912 WILLIAMSON DRIVE
(PHILIP ROTHSTEIN
HOUSE)

Nature of Project:
Addition: changes to previously
approved addition façades
(COA 131-16-CA)

Certificate of Appropriateness (COA)

COA #: 131-16-CA & 014-18-CA

WINDOW AND GUTTER DETAILS

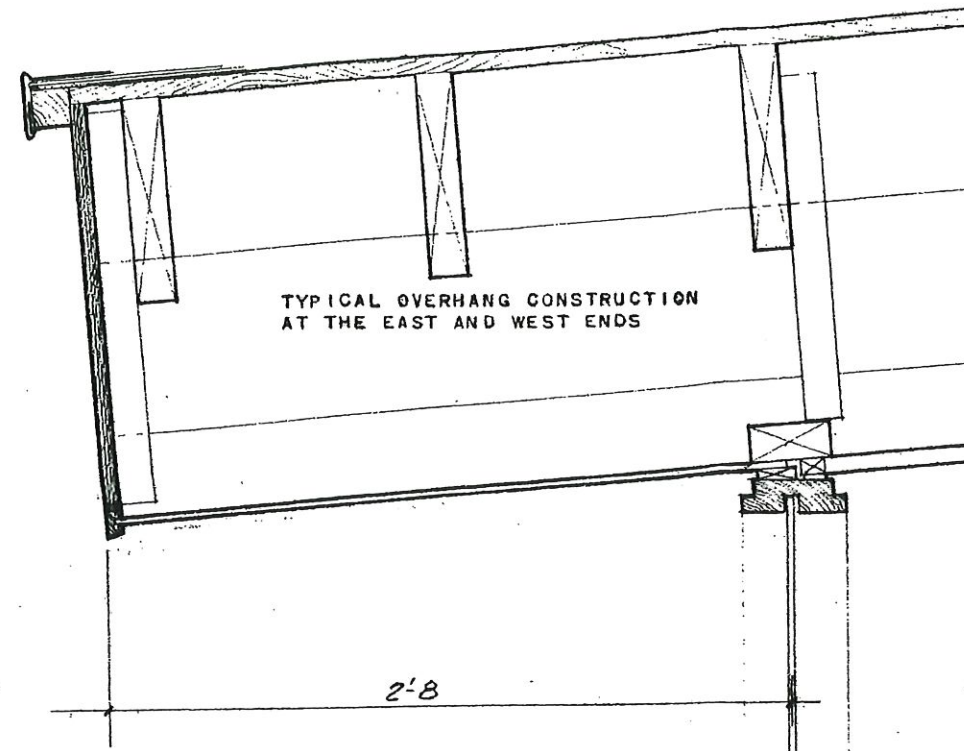
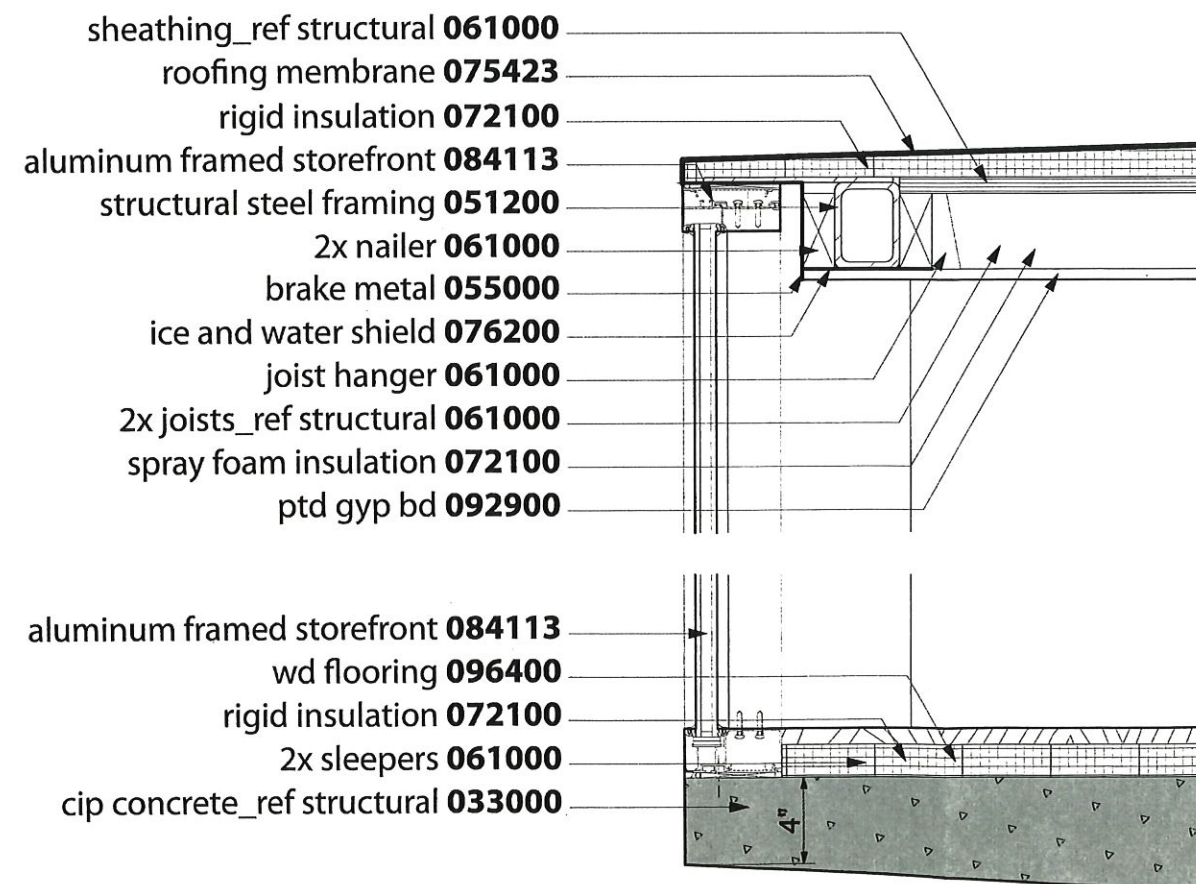
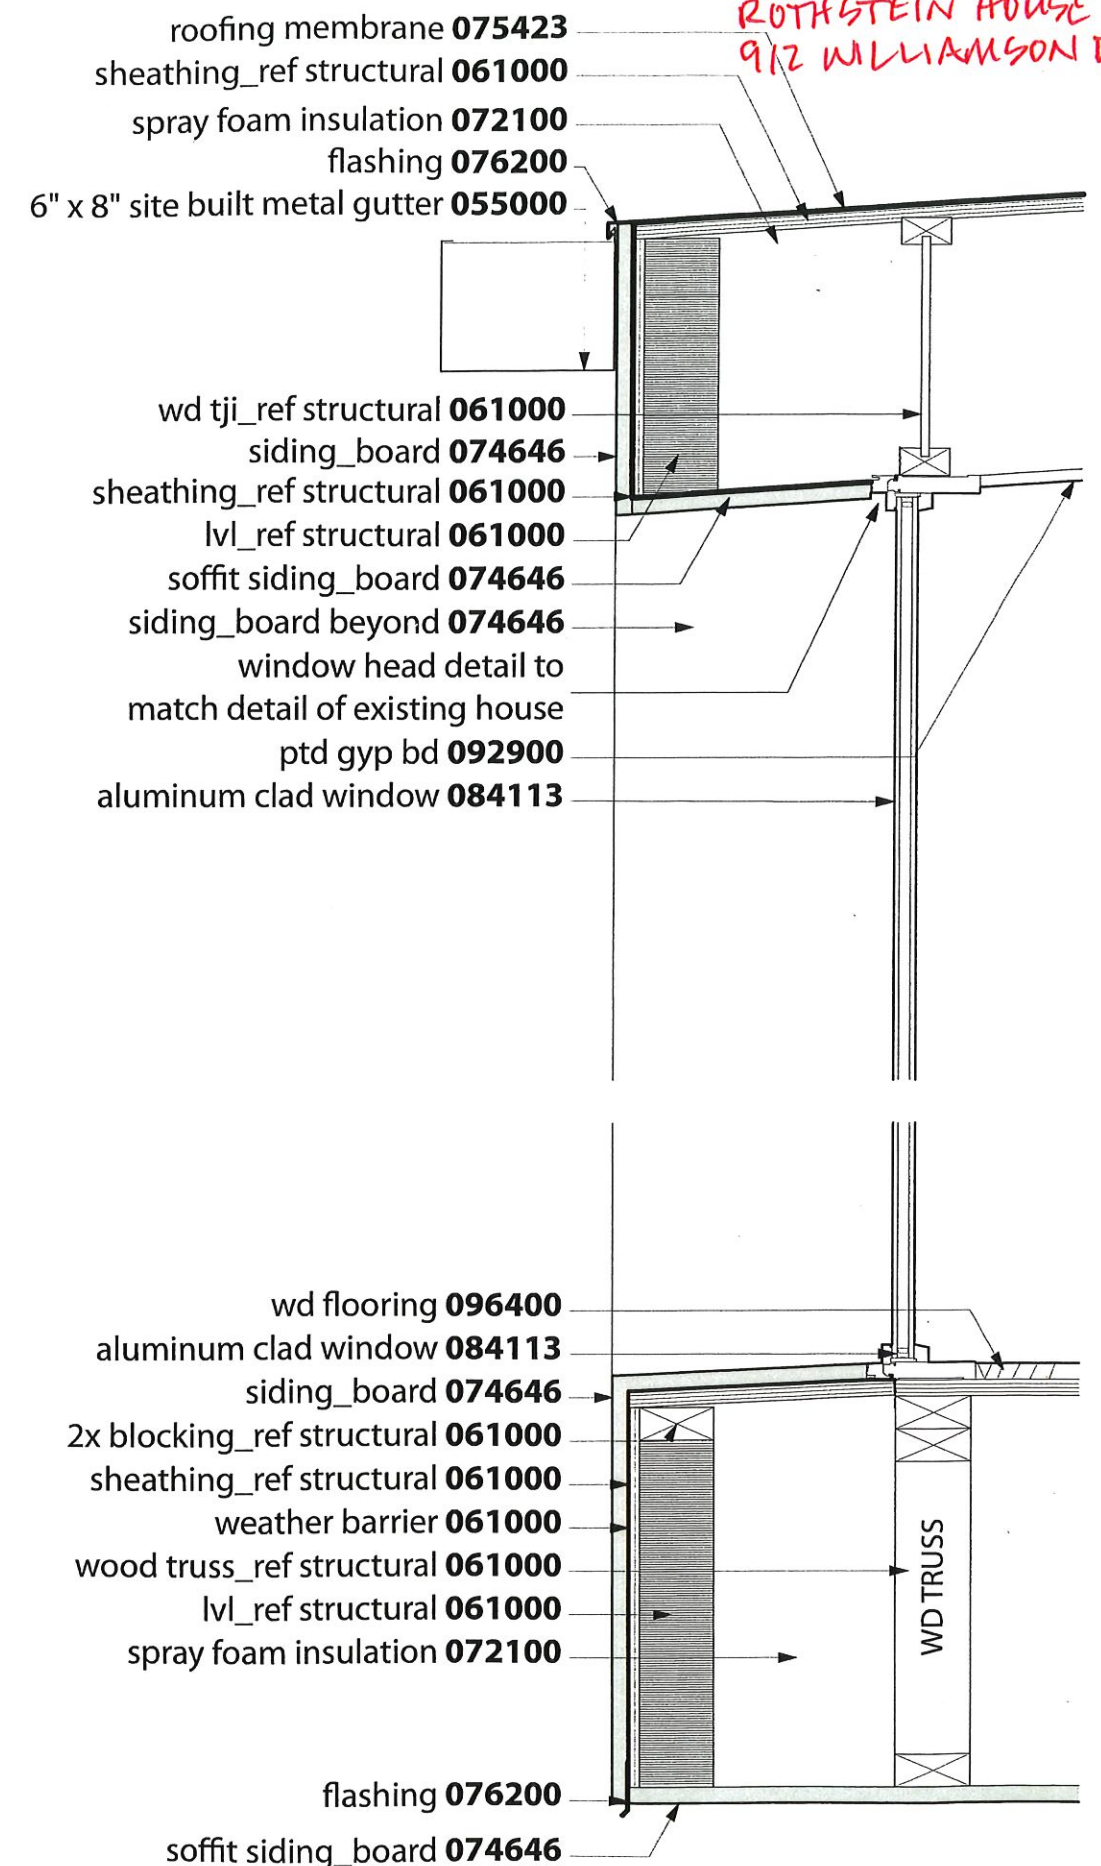
In our research, we noticed that in all our submissions, we show the windows on the south facade as having the same header detail as the windows in the original house (that being, windows go all the way up to the ceiling). We also found that we never assigned a height or height to match for the windows on the south facade of the addition. In fact, when we went back looking for this information, we noticed that the header heights on the addition windows have always been higher than the horizontal high mullion on the existing house windows.

All that said, you will notice we are not assigned a height to the addition's south windows, but rather committing to keeping the same detail. We think this will look much better, be more in harmony with the existing house, and are above all confident no one will ever be able to tell that the window height on the addition is a matter of inches higher than the horizontal mullion on the existing house.

WEST ELEVATION WINDOW CHANGES

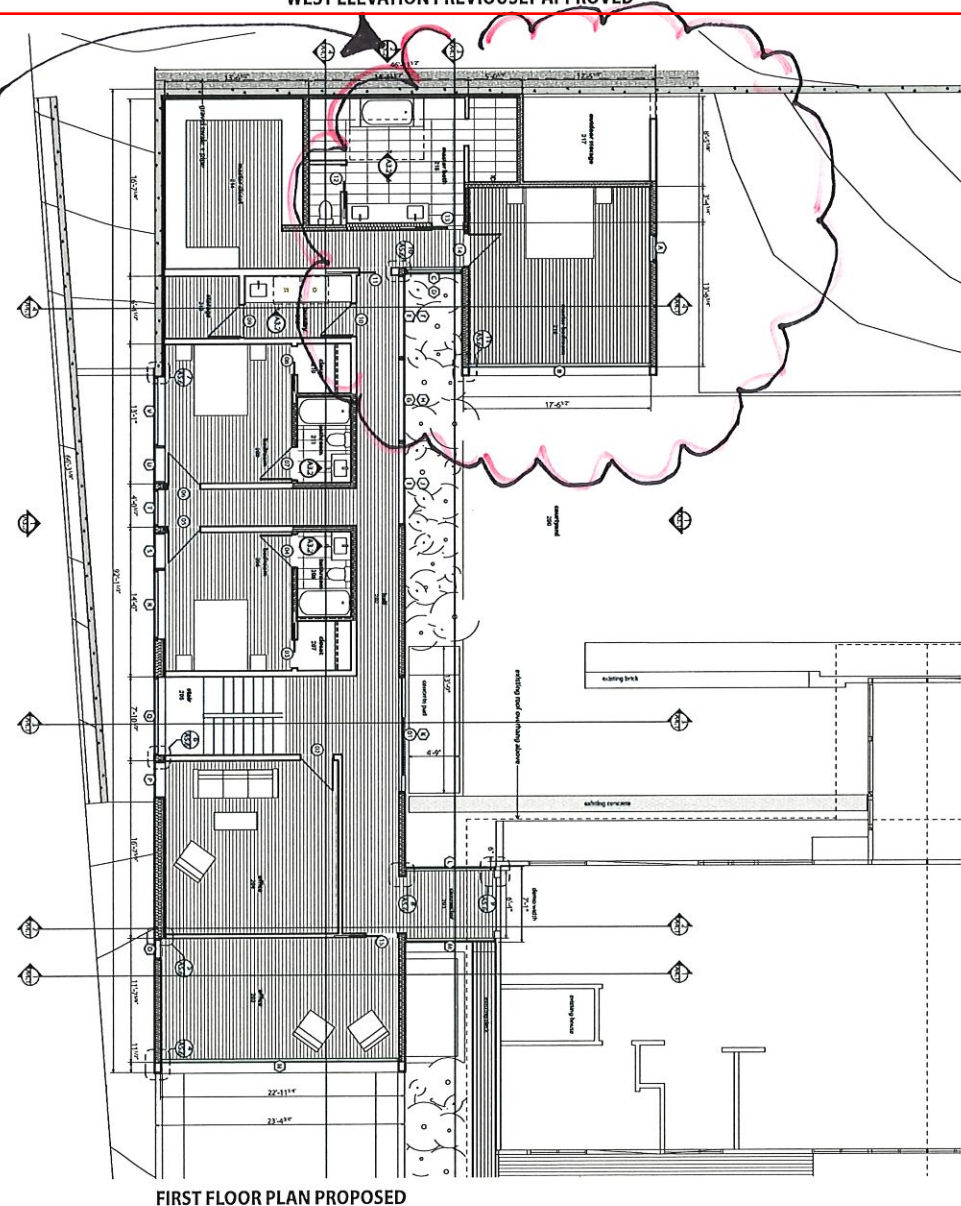
TYPE no change

LAYOUT high transom removed in response to lowered ceiling
number and location altered in response to plan changes
operables added at locations required for egress

SOUTH ELEVATION PROPOSED

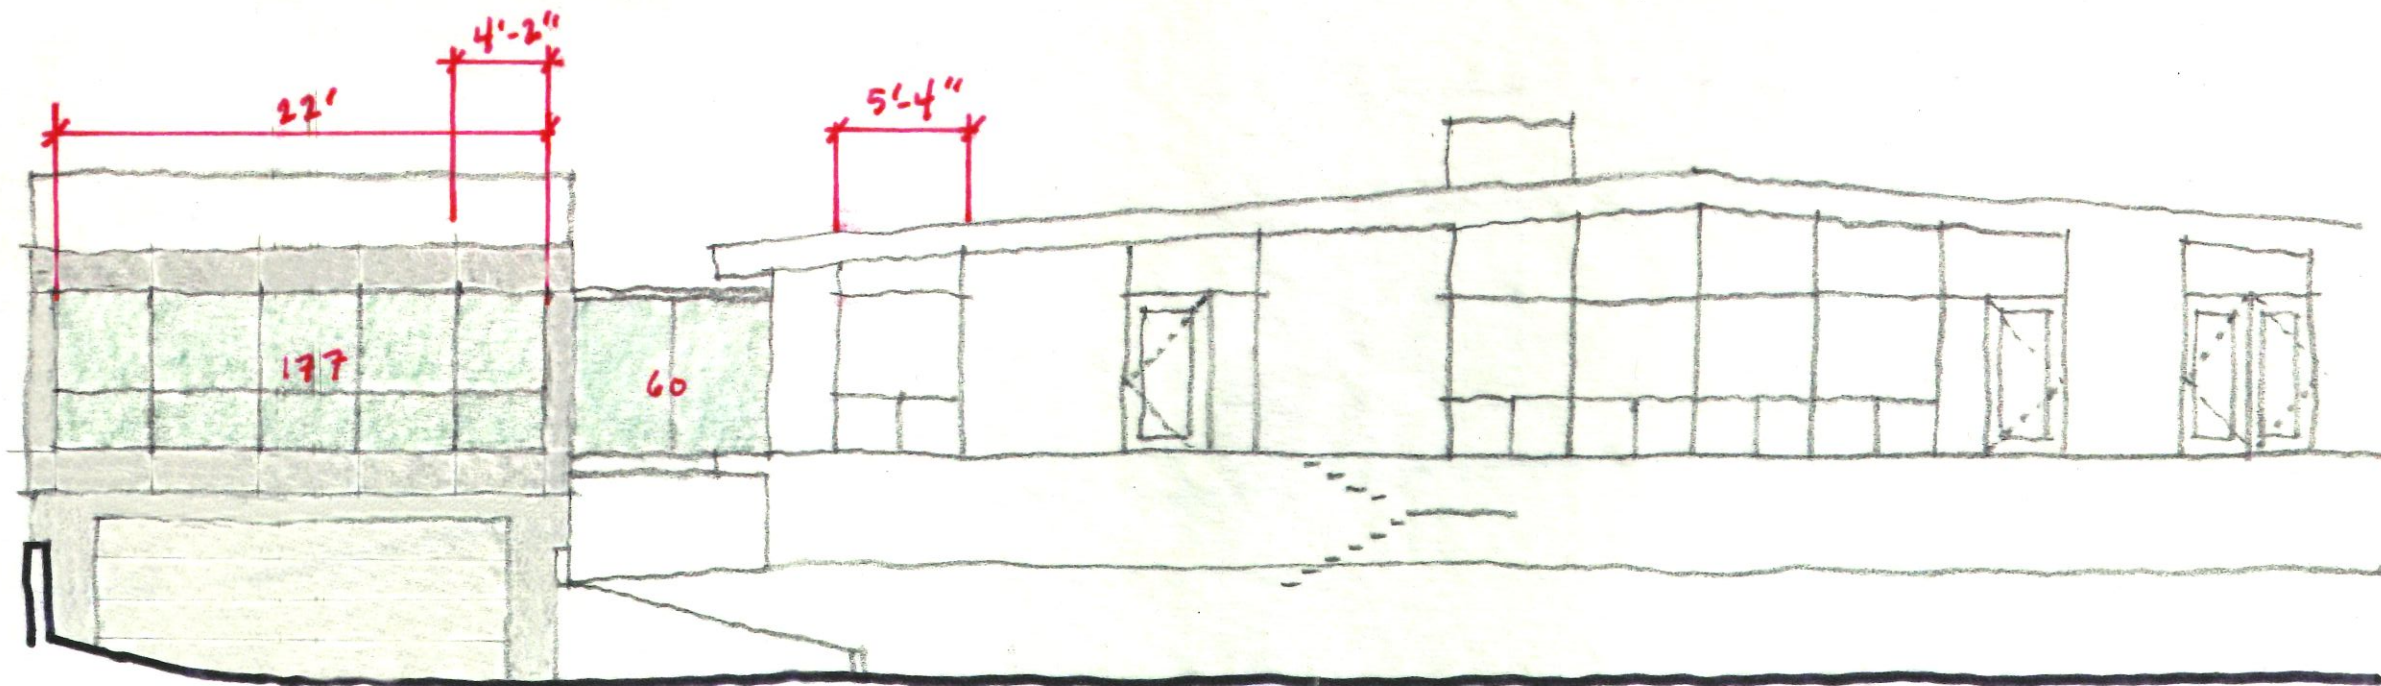
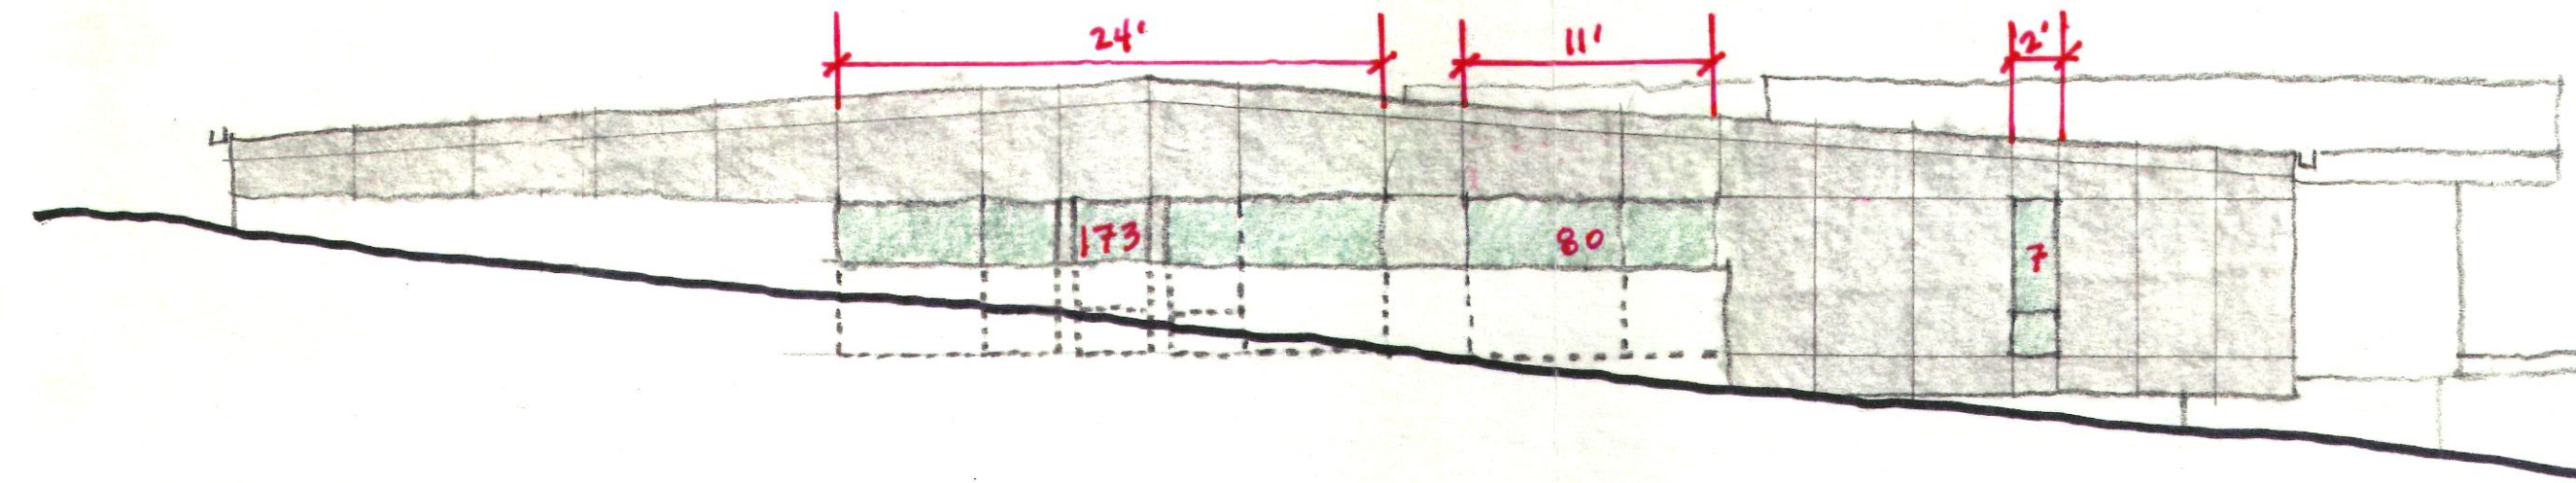
1. Elimination of horizontal break in front facade windows. **Reason for change:** The lower hopper windows are no longer operable and therefore should not mimic the lower hopper windows in the main house, which are operable. We believe that keeping the horizontal mullions would be a false imitation of the window patterns of the existing house given they are there to separate the operable from the fixed windows.

2. Elimination of vertical division in glass hyphen. **Reason for change:** We were not aware that one single window could span the glass hyphen at the 12 22 16 COA submission. When we learned this could be accomplished, we changed the design with the belief that no mullions in the glass hyphen creates a pure glass hyphen. We do not believe the design illustrated in the proposed glass hyphen compromises the design intent of what was approved on 12 22 16.

3. Reduced window amount from five to four on the front facade. **Reason for change:** A 5'-6" window width is more similar in width to the existing house (5'-2") than the 4'-2" width approved on 12 22 16.
